# MEMO

**To:** Kristopher Byrd, Well Construction and Compliance Section Manager  
**From:** Travis Kelly, Well Construction Program Coordinator  
**Subject:** Review of Water Right Application G-18903  
**Date:** February 4, 2021

# Groundwater Application Review Summary Form

Application # G- 18903

**Stream-Depletion Estimates for (A) POA #1 and (B) POA #4. Stream-depletion for POA #2 will be similar to POA #1 and stream-depletion for POA #3 will be similar to POA #4**

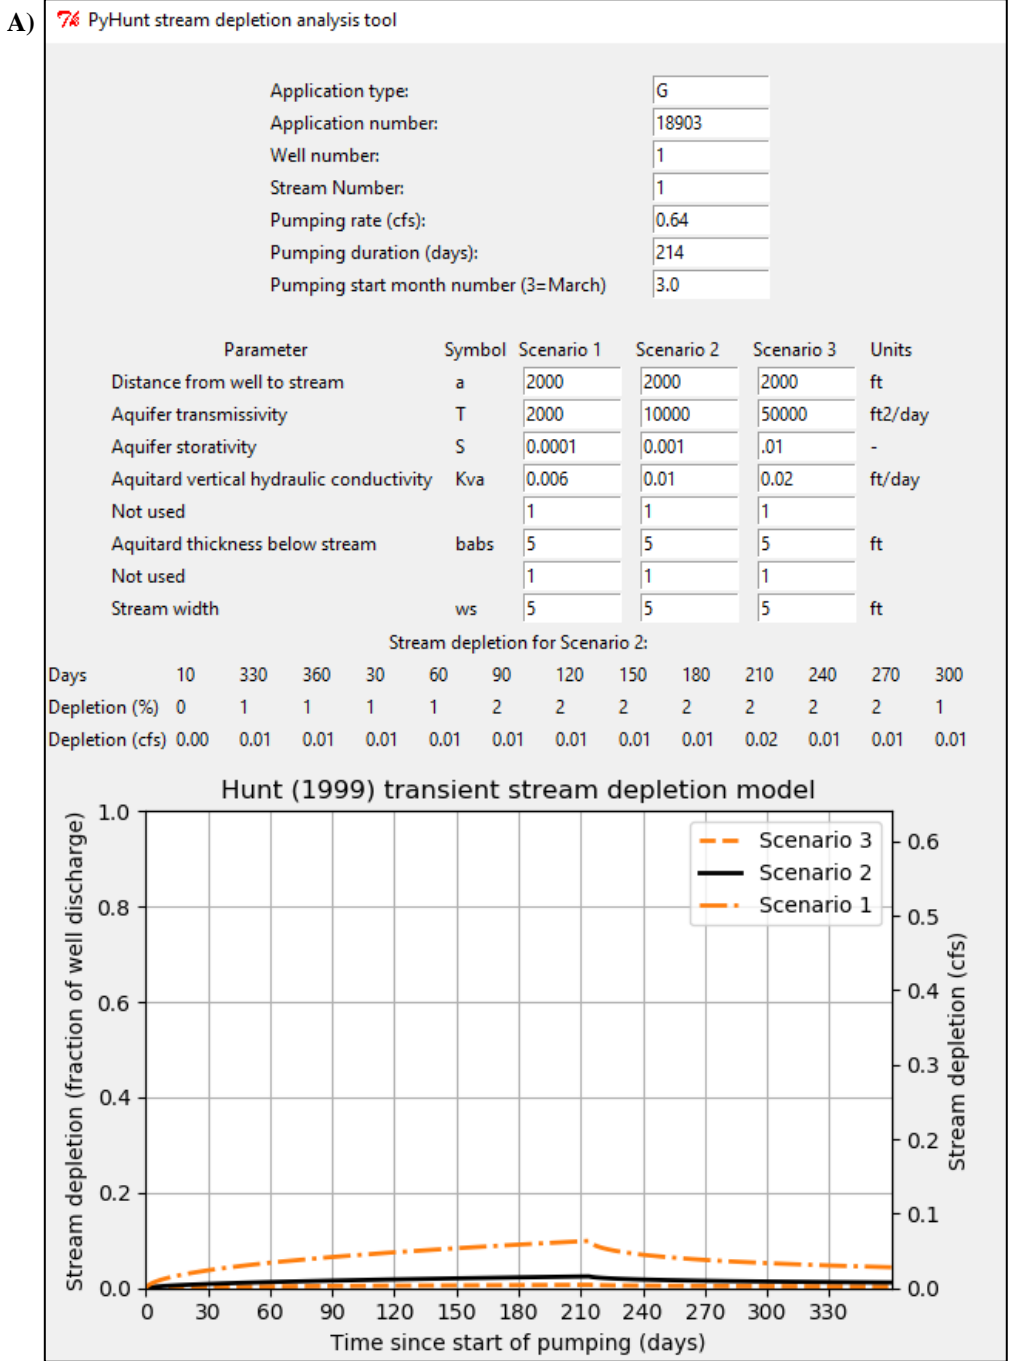
**Comments:** Stream-depletion was estimated using the Hunt-1999 stream-depletion model with model parameters taken from the OWRD Pump Test Database and Herrera et al., (2014). Stream-depletion estimates are shown below.

C6. **SW / GW Remarks and Conditions:** The applicant’s proposed POAs would be producing from an aquifer system that is unconfined and found to be hydraulically-connected to surface water – specifically tributaries to the Willamette River. The distance between the POAs and surface water is less than 1 mile for all proposed POAs. Stream-depletion estimates using the Hunt-1999 model estimated that interference to surface water from POAs #1 and #2 is not likely to result in the Potential for Substantial Interference (as defined in OAR 690-0090) but **interference from POAs #3 and #4 is likely to result in the Potential for Substantial Interference.**

**Estimated interference for POA #1 to (A) nearest domestic well and (B) nearest permitted water right; POA #1 represents the shortest distances and thus highest likelihood of interference**

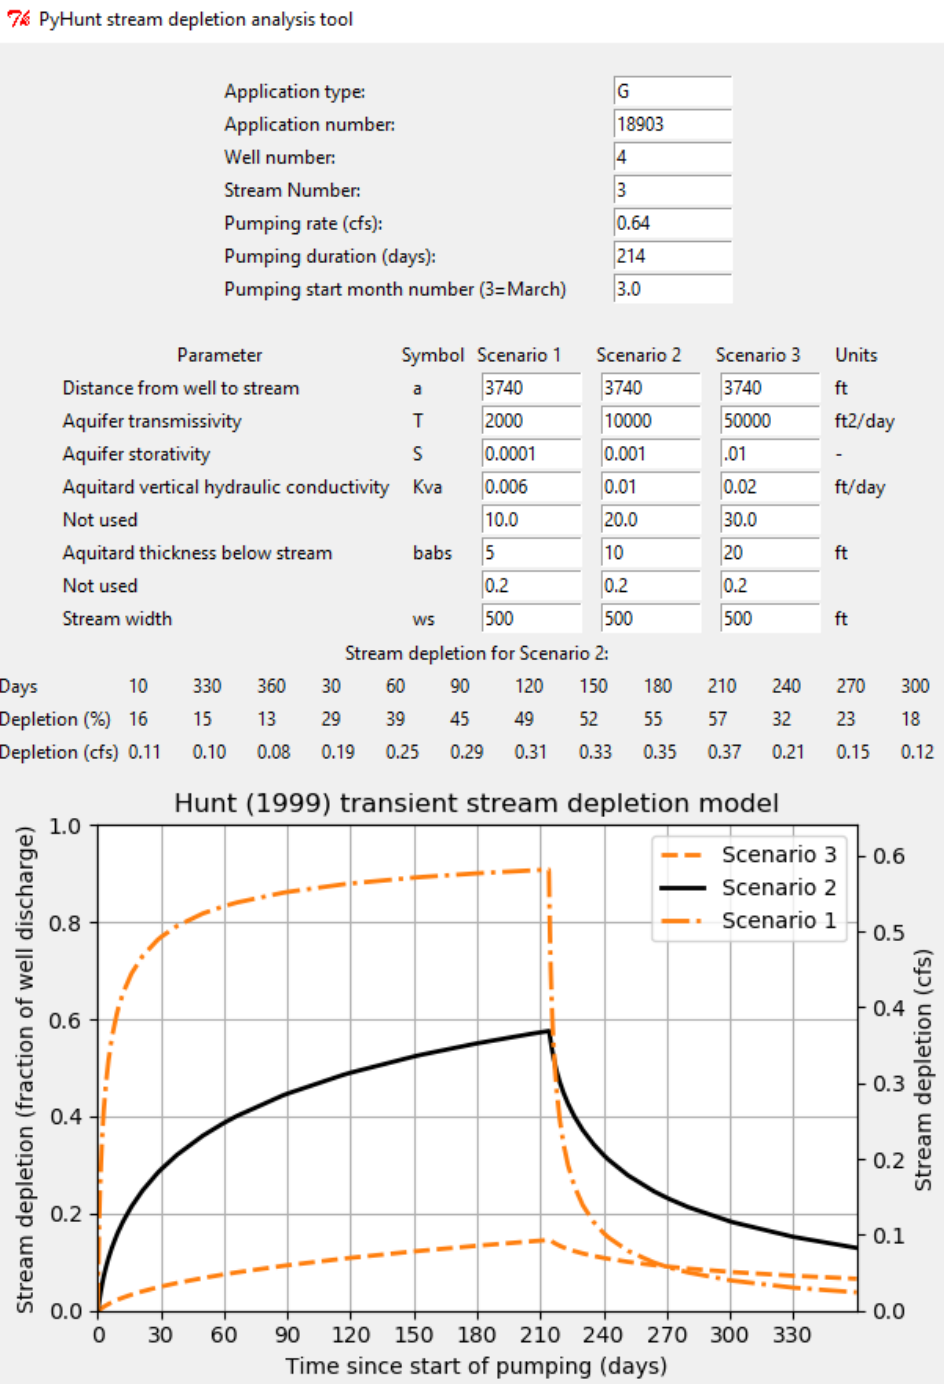
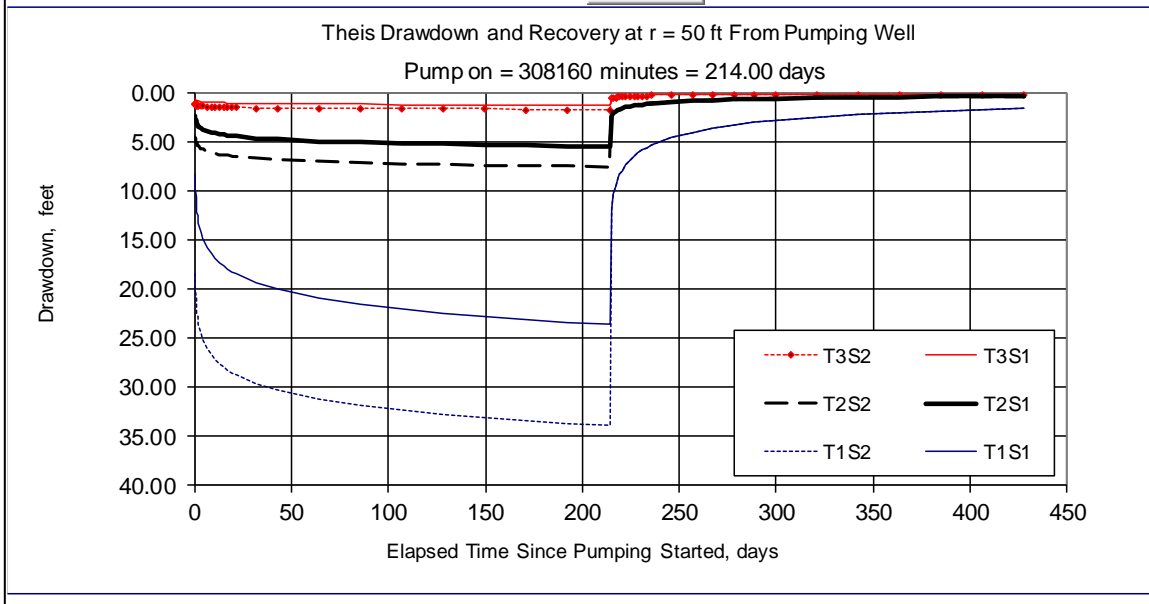
B3. **Groundwater availability remarks:** The Department has not performed an official calculation of recharge versus existing appropriation for the Willamette aquifer system so Over-Appropriation cannot be addressed as defined in OAR 690-400-0010(11). Three of the four proposed POAs are in areas densely populated by rural development (i.e., domestic wells) and also existing groundwater rights. The nearest permitted groundwater POAs to each of the proposed POAs are 377 ft to POA #1, 3990 ft to POA #2, 480 ft to POA #3, and 580 ft to POA #4. The nearest possible domestic wells are 50 ft to POA #1, 1930 ft to POA #2, 715 ft to POA #3, and 290 ft to POA #4. Transmissivity estimates from pumping test on wells in the area range from approximately 2000 ft<sup>2</sup>/d to 50,000 ft<sup>2</sup>/d and storativity is likely to be 0.01 to 0.0001 (see Herrera et al., 2014). Using these values and distances in a Theis-Drawdown model, seasonal interference to existing wells, either domestic or permitted, could reasonably exceed 20 ft at a distance of 50 ft and 10 ft at distances around 300 ft. Many wells in the vicinity of the proposed POAs are 50-100 ft deep with reported SWLs near 10 ft below land surface. **A 20 ft, or even 10 ft, increase in seasonal interference could result in injury to existing water users.**
